**PLANNING DEPARTMENT ADMINISTRATIVE PUBLIC HEARING
SUMMIT COUNTY, UTAH
March 21, 2024**

Planning Department Staff Report

Subject: 560 Park Avenue
Application: PL-23-05789
Author: Lillian Zollinger, Planner II
Date: March 21, 2024
Type of Item: Historic District Design Review

(I) Review the Historic District Design Review (HDDR) for the construction of a new Single-Family Dwelling at 560 Park Avenue, (II) conduct a public hearing, and (III) consider approving the HDDR based on the Findings of Fact, Conclusions of Law, and Conditions of Approval outlined in the Draft Final Action Letter (Exhibit A).

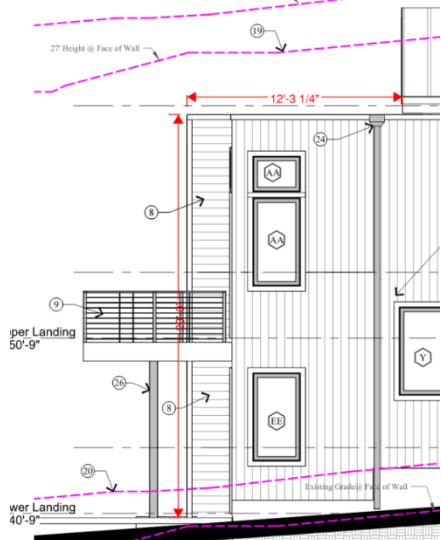
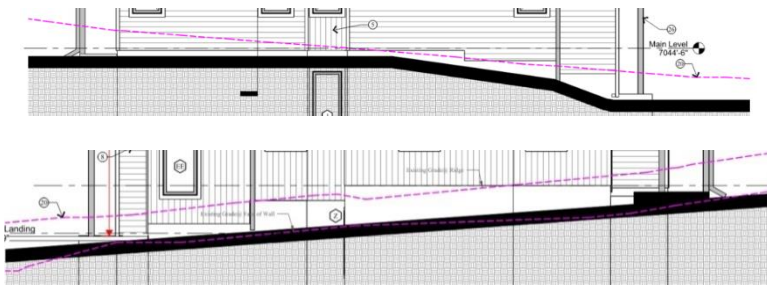
Zoning Requirement	Analysis
Building Height- 27 feet above Existing Grade	Complies: 26’ 7”
Maximum interior height of 35 feet, measured from the lowest finish floor plane to the point of the highest wall top plate that supports the ceiling joists or roof rafters	Complies: 29’ 6” maximum interior height 
A ten foot (10’) minimum horizontal step in the downhill façade is required. The horizontal step shall take place at a maximum height of twenty three feet (23’) from where the Building Footprint meets the lowest point of existing Grade.	Complies: The structure steps back in the downhill façade for 12 feet, three inches at 23 feet in height.

Roof Pitch- 7:12 -12:12	Complies: 7:12
Final Grade within 4 feet of Existing Grade	Complies: The proposed final grade is within four feet of existing grade as shown below:

Figure 1: Modified landscape plan as approved by Planning Director on March 2, 2023.

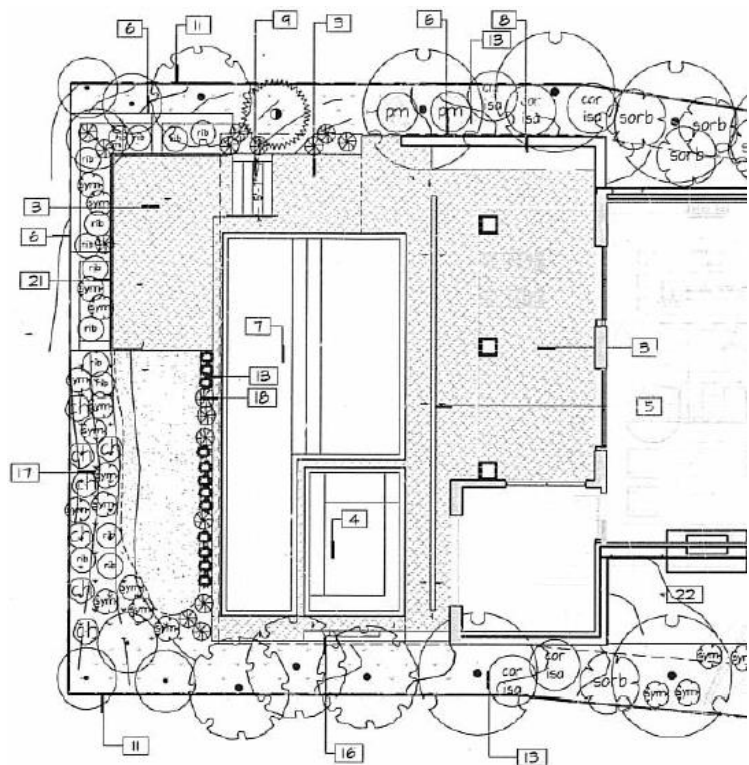
Following a public hearing held on March 2, 2023, the Planning Director conditionally approved a landscape plan that included a pool and hot tub with a combined size of approximately 37 feet by 20 feet (see Figure 1, right). Condition of Approval #1 of the Final Action Letter required the Applicant to obtain a Conditional Use Permit (CUP) for the swimming pool prior to obtaining a building permit for the pool installation.

During the March 2, 2023, public hearing, the Planning Director reiterated landscapes in Historic Districts ideally return to a natural or original state, with minimal manipulation of the site (See Minutes, p. 8, Exhibit F). The approved modified landscape plan included three “levels”: the first contained the patio and proposed pool area, the second was a smaller patio that stepped down northwest toward the rear of the property, and the third was a lower level to the southwest of the pool that was to

Figure 2: Proposed landscape plan

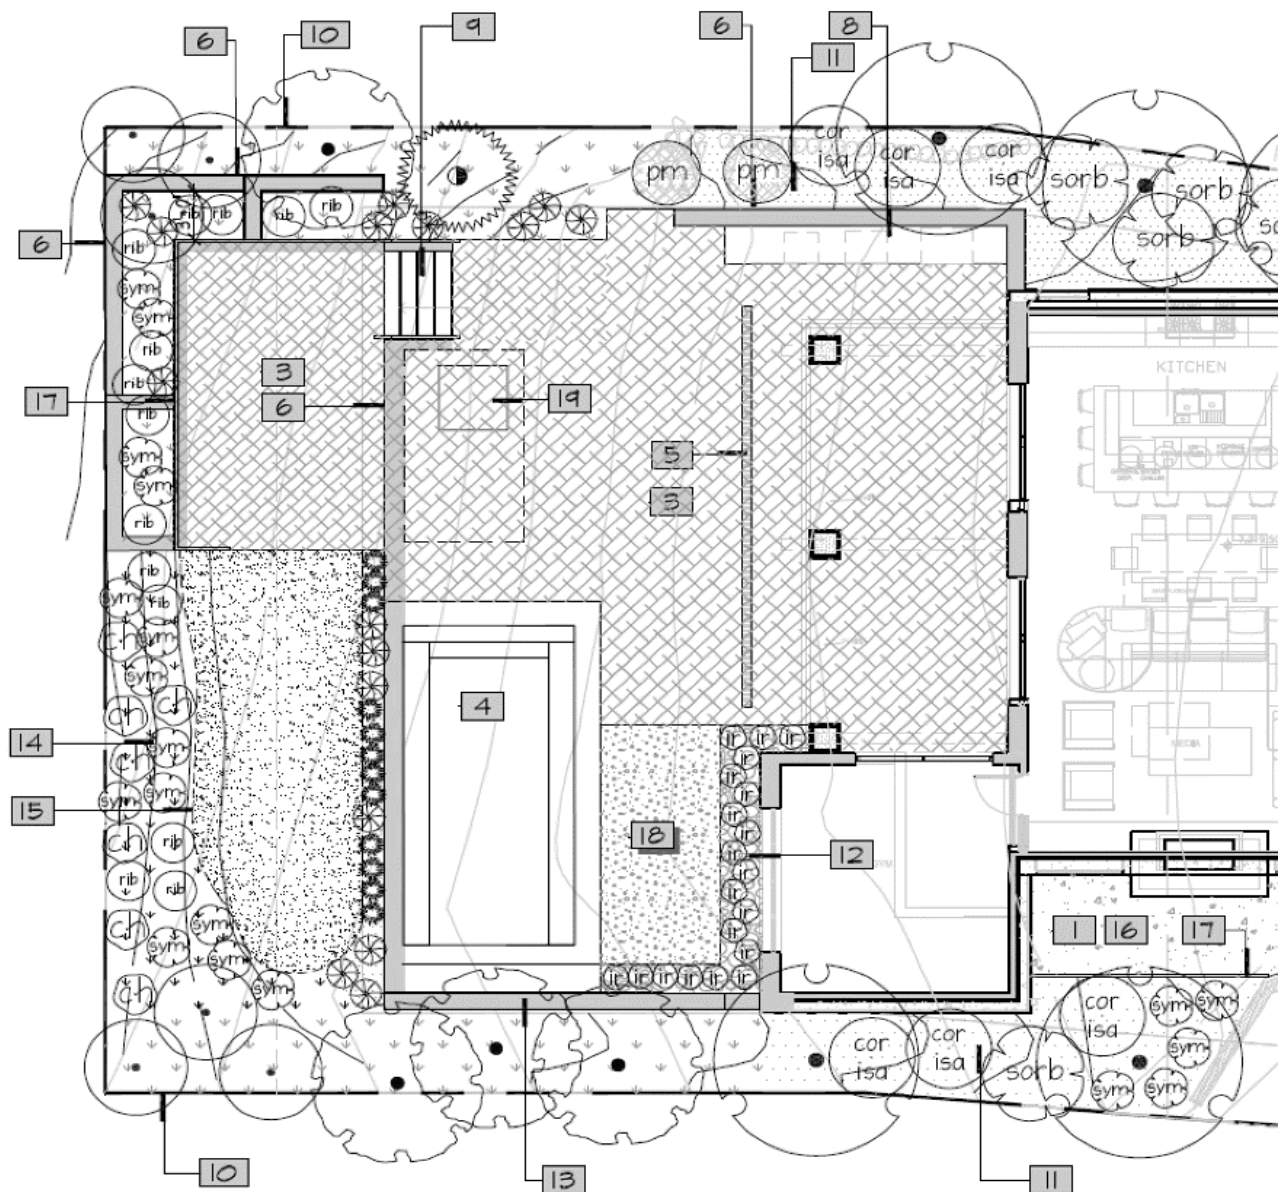
The current proposal (Figure 3, above) is to modify this approved landscape plan by reducing the size of the swimming pool walls to accommodate additional plantings. Additional trees and shrubs have been proposed in the perimeter of this area. The northwestern corner of the property would still have three four-foot-tall retaining walls that would be utilized as planters to obscure the concrete. The westernmost retaining wall would be located immediately adjacent to the rear property line and would not be

obscured by plant materials.

Figure 1: Applicant's Site Plan Indicating Location of Chiller Unit

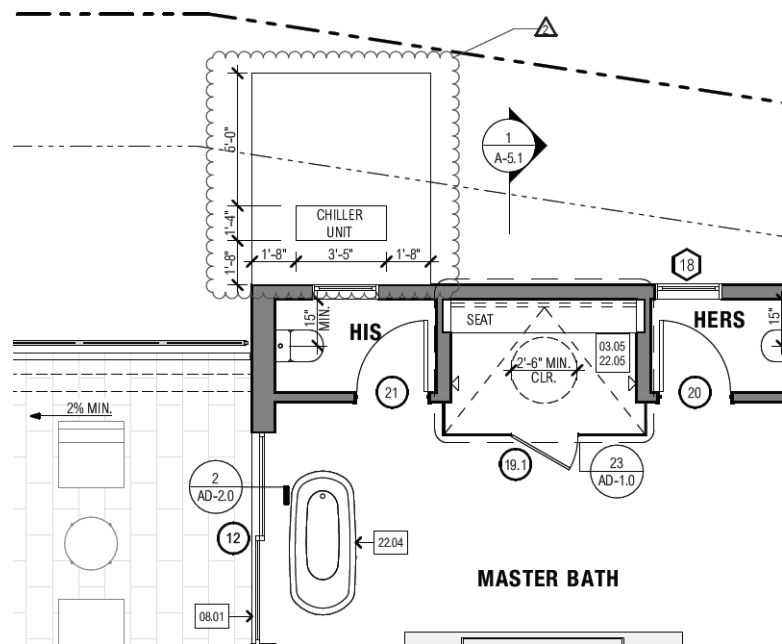
Section [§15-13-8](#) of the Land Management Code outlines the design standards for new infill construction in historic districts. Because this modification request is specifically focused on siding and mechanical equipment this section will focus on those items.
